# COMBINED LINWOOD/EASTERN INTERCHANGE & US 50/RED BANK INTERCHANGE FOCUS AREA ADVISORY COMMITTEE MEETING NOTES

EASTERN CORRIDOR SEGMENTS II AND III (PID 86462)

## MEETING #3 NOTES

Sept. 7, 2018

**Figure X-2B-5**  
**GRADE SEPARATED INTERCHANGE TO CONNECT**  
**WILMER AVENUE TO WOOSTER ROAD**

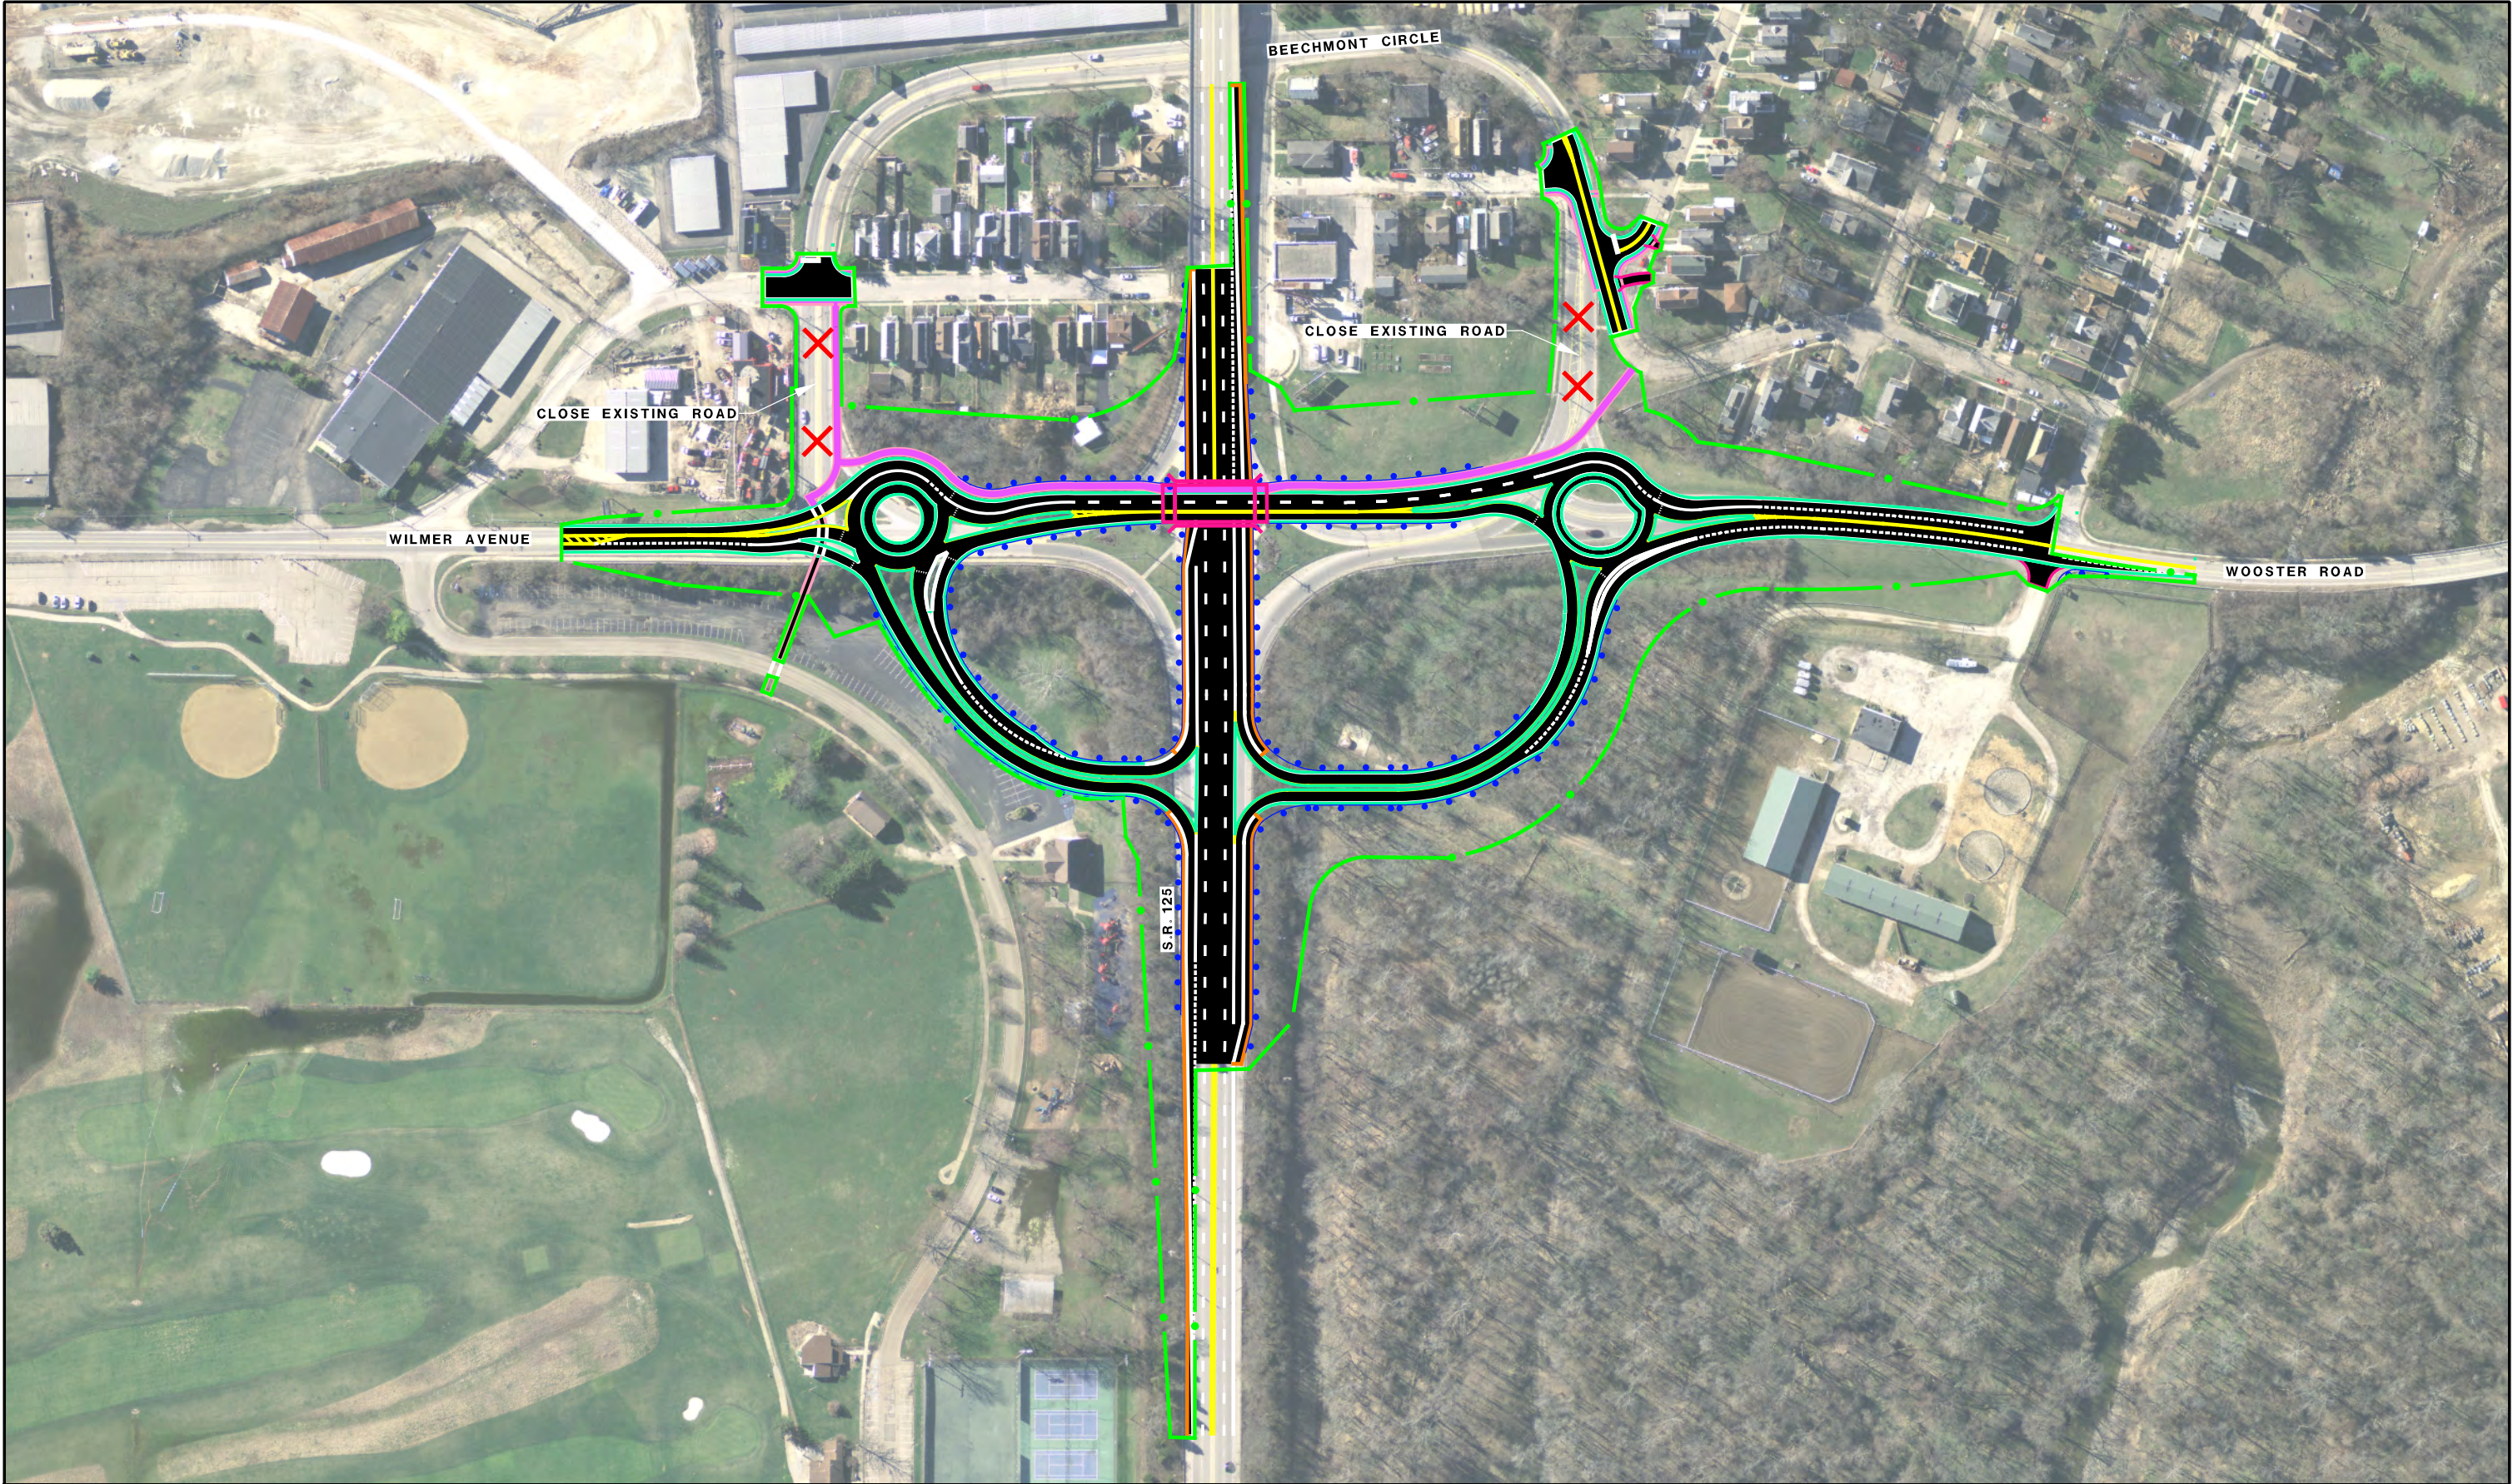
- This alternative should be evaluated with X-2b-2 and X-2b-2a.
- Traffic simulations show a significant increase in PM peak hour delays. Traffic traveling down Wooster to east on Beechmont left no gaps for other traffic to enter the roundabout.
- This concept would result in the loss of parking spaces in the Lunken Playfield parking lot, though the number of spaces lost is not yet known.
- While an improvement over the No Build alternative, this option did not work as well as the signalized intersection options in traffic simulations and is more expensive.

- No further study. Traffic simulations showed PM peak delays.

**Figure I-25B**  
DUAL WESTBOUND TURN LANES  
AND DUAL NORTHBOUND THROUGH LANES

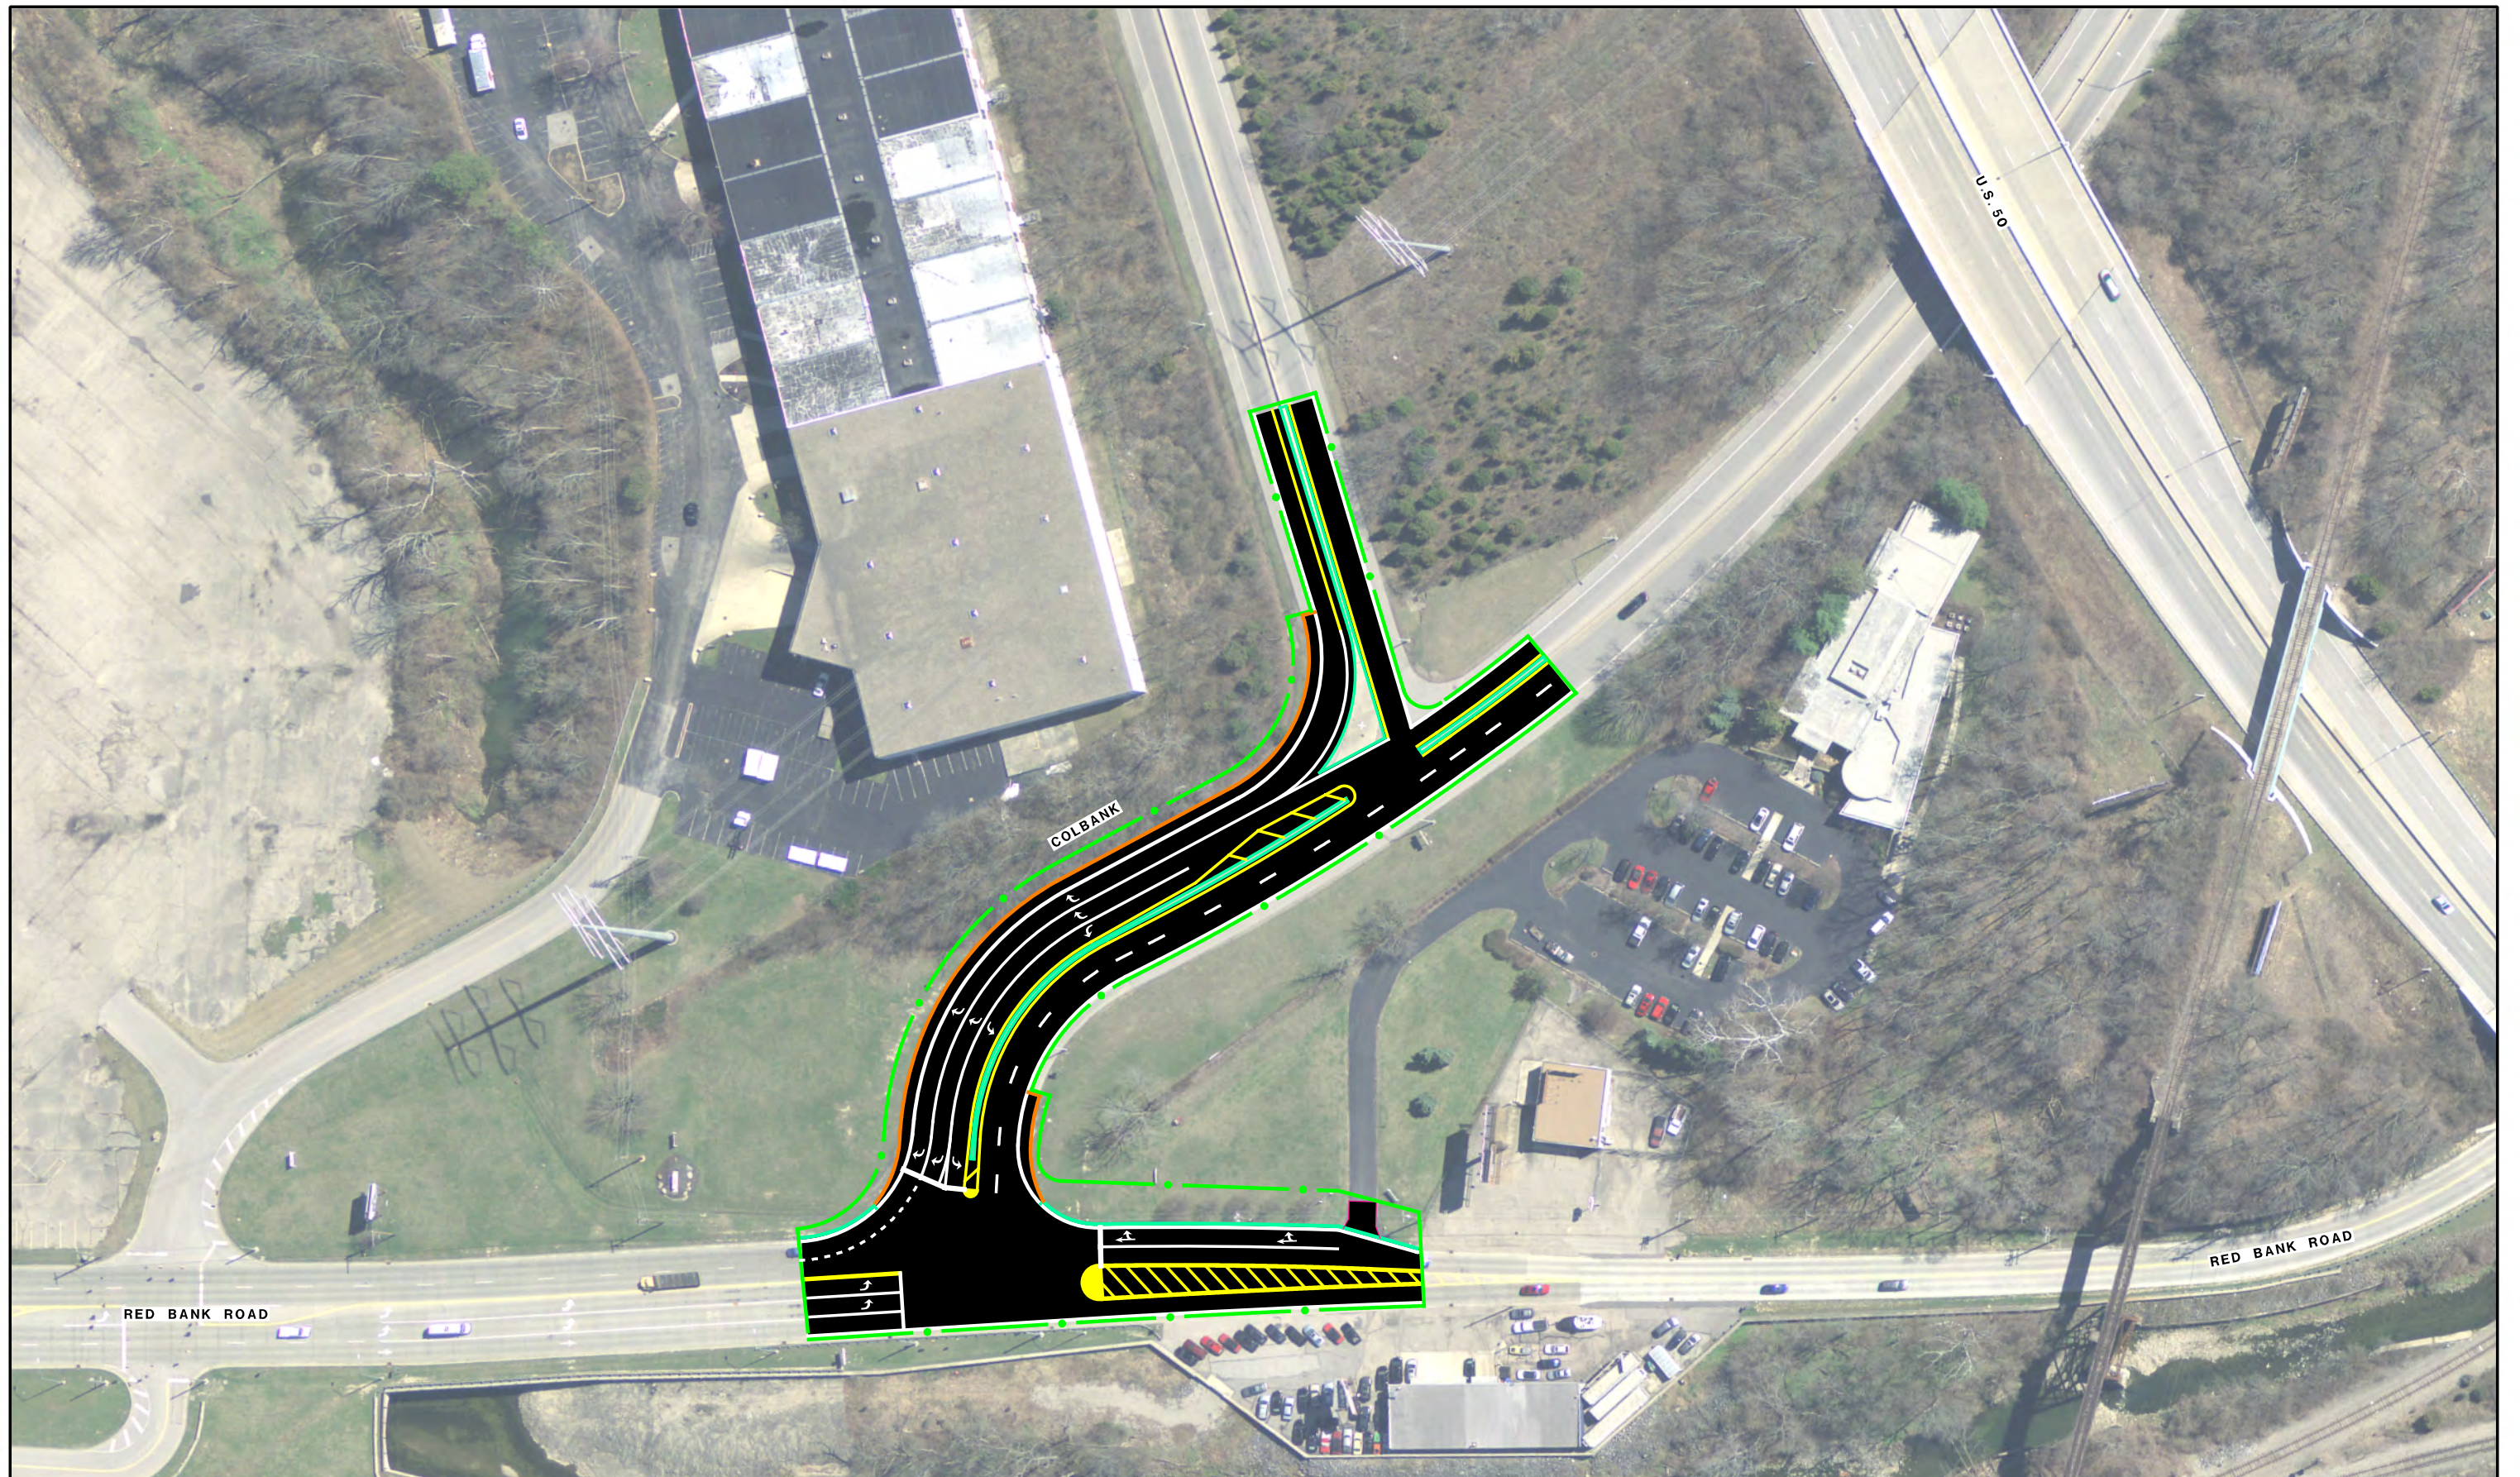
- This concept is an alternative to others designed to improve operations at the Red Bank/US 50 interchange: I-25c, X-4a, X-4c-2, X-4d and X-4d-1.
- Simulations demonstrate this concept would provide good improvements to traffic operations, reducing AM peak hour delays by 85 percent and PM peak hour delays by 43 percent.
- The committee discussed installing a traffic signal to stop the northbound movement at the intersection of Colbank and US 50 ramp and provide a turn arrow so that drivers turning left from Colbank to the westbound US 50 ramp don’t have to stop a second time but could move continually through the intersection (similar to the existing intersection at Glenway and Glenhills Way). The signal could be equipped with a sensor to display an arrow only when the queue is long.
